**S-TYPE**

S307-02

**SERVICE****TECHNICAL BULLETIN****Stuck Ignition Key –  
Modify J-Gate Interlock Lever –  
Service Action S114**MODEL 2000 MY-ON  
S-TYPE

VIN L00600-L11869

ILLUSTRATION 1

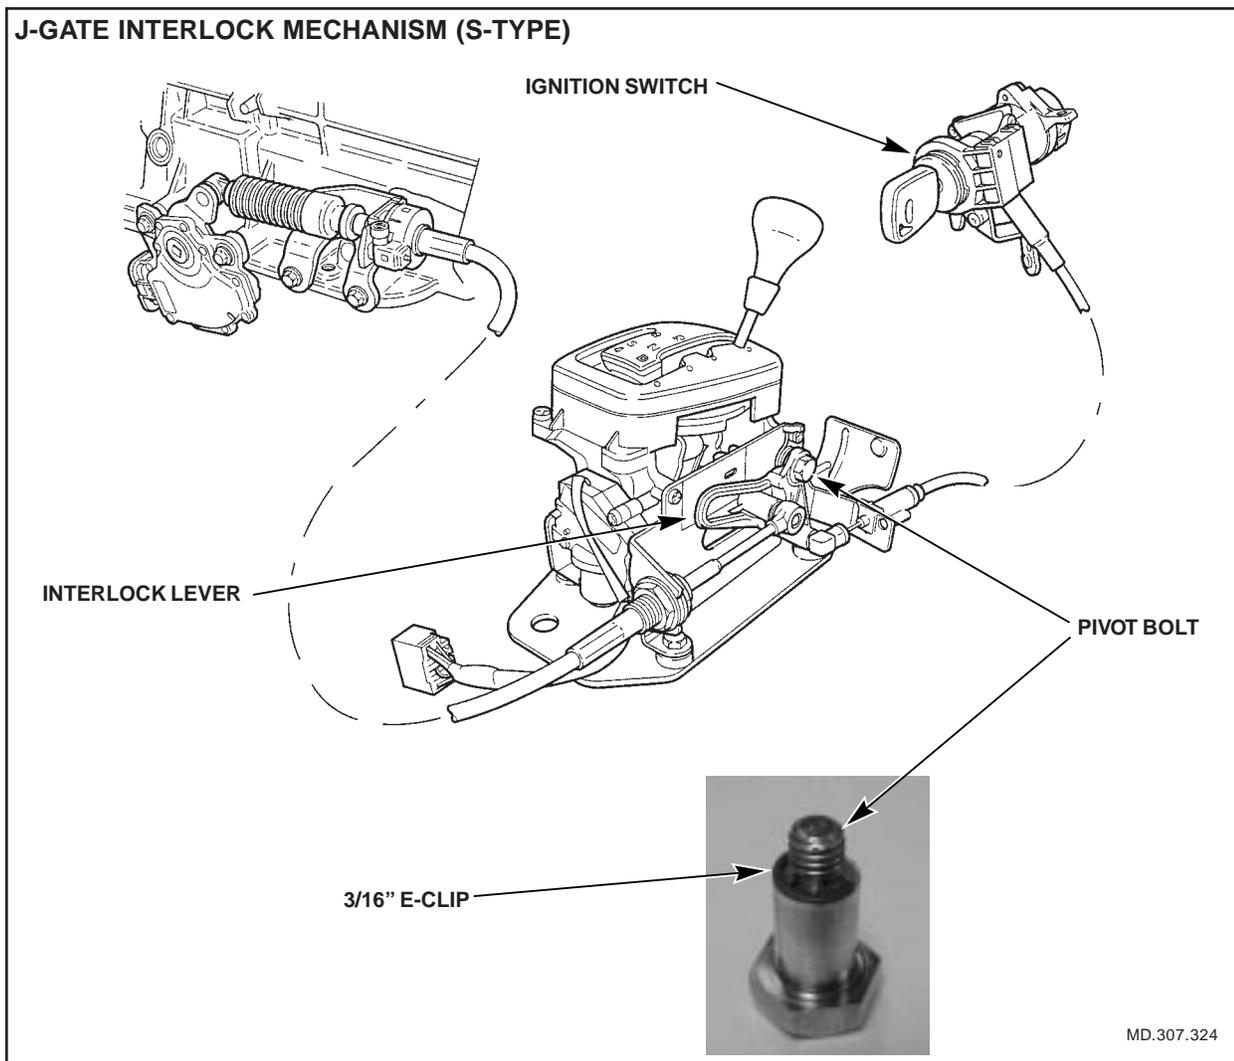
Some 2000 MY S-TYPE vehicles within the above VIN range may, under high temperature conditions, experience a malfunction of the J-Gate interlock mechanism which results in the inability to remove the ignition key when the gear selector lever is placed in 'Park'.

This bulletin provides a procedure to install an e-clip on the pivot bolt to increase the clearance of the pivot of the interlock lever.

6. On the right side of the J-gate assembly, remove the pivot bolt that retains the interlock lever (Illustration 1).
7. Check for any excess thread locking compound on the interlock lever. Wipe off any excess.
8. Install a 3/16 inch e-clip on to the bolt (Illustration 1), **ensuring that the e-clip does not extend beyond the shank of the bolt. Make sure that the bolt turns freely in the lever.** If necessary, use a reamer to bevel the opening of the lever.
9. Reinstall the bolt. Do not use thread locking compound.
10. Ensure that the interlock lever moves freely and that the key can be easily removed when the range selector lever is in 'Park'.
11. Reassemble the console components in the vehicle.
